Fuel Tank Shield Rattle Noise

Service Category Vehicle Exterior

Section Exterior Panels/Trim

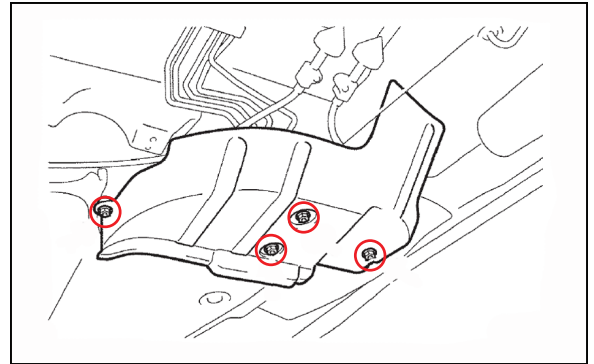
1. Remove the No. 1 fuel tank protector by removing the 4 nuts and then remove the No. 1 fuel tank protector. **Figure 1.**

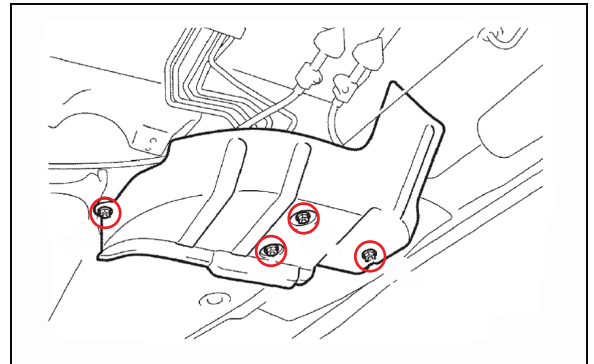
2. Install the No. 1 fuel tank protector with the 4 nuts. **Figure 2.**
Torque: 5.5 N*m (56 kgf*cm, 19 in*lbf)
